August 20, 2012

SUBJECT: Comment Letter: Draft Policy for Toxicity Assessment and Control

CLEAN WATER ASSOCIATION TECHNICAL COMMENTS PROPOSED POLICY FOR TOXICITY ASSESSMENT AND CONTROL

Figure 1. Fathead minnow survival effects between 0% and 25%. All tests conducted by the Districts San Jose Creek Water Quality Laboratory in 2009.

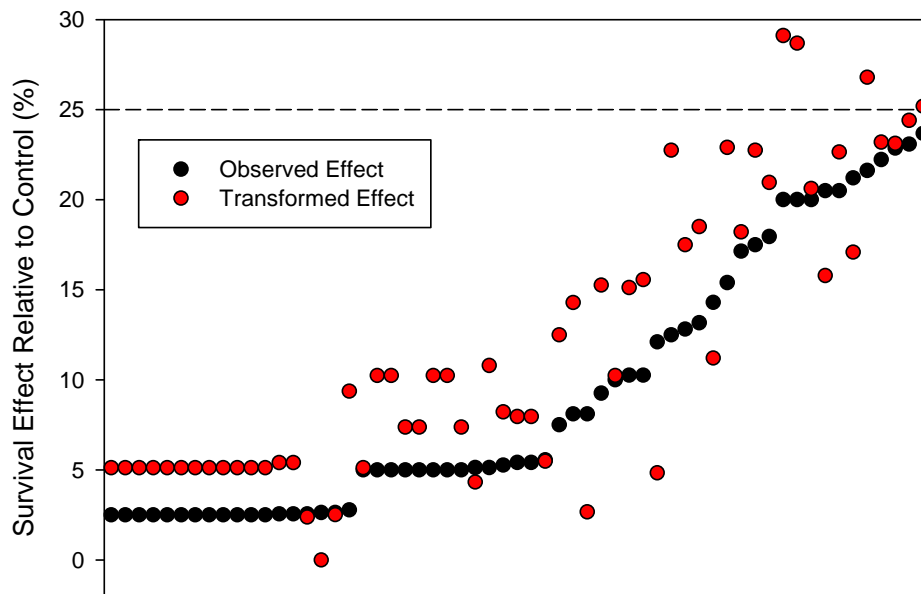
14. The Arc-sine Square Root Transformed Data Contains an Apparent Bias.

Transforming percentage data (e.g., survival responses) is a commonly accepted practice prior to conducting hypothesis testing where normal distribution assumptions are critical in the statistical analysis. When using the commonly applied arc-sine transformation, a bias resulting in the calculated response or effect using the transformed data is typically greater than the actual observed response of effect. This bias poses little concern when traditional hypothesis testing is conducted because all transformed treatments are compared directly to the transformed control. However, with the TST hypothesis test, the transformed treatments are compared to 75% of the transformed control. By not similarly transforming the binomial “b” or bioequivalency factor (75% for chronic tests and 80% for acute tests), this bias will significantly increase the probability of identifying a sample as toxic. The effect and magnitude of this bias in real world samples exhibiting observed effects ranging from zero (0) to 25% are presented in Figure 2.

After reviewing the EPA's TST spreadsheet tool (version 1.5), it is clear that all effects are to be calculated using original, not transformed data. Considering that there is significant positive bias associated with calculating percent effects at the IWC using transformed data, EPA TST tools calculate percent effects using untransformed data, and that accurate calculations of these estimates are critical for reasonable potential determination, MDEL evaluation, and TRE trigger determination, all references and examples in the Revised Draft Policy should clearly indicate that original units are to be used for these calculations.
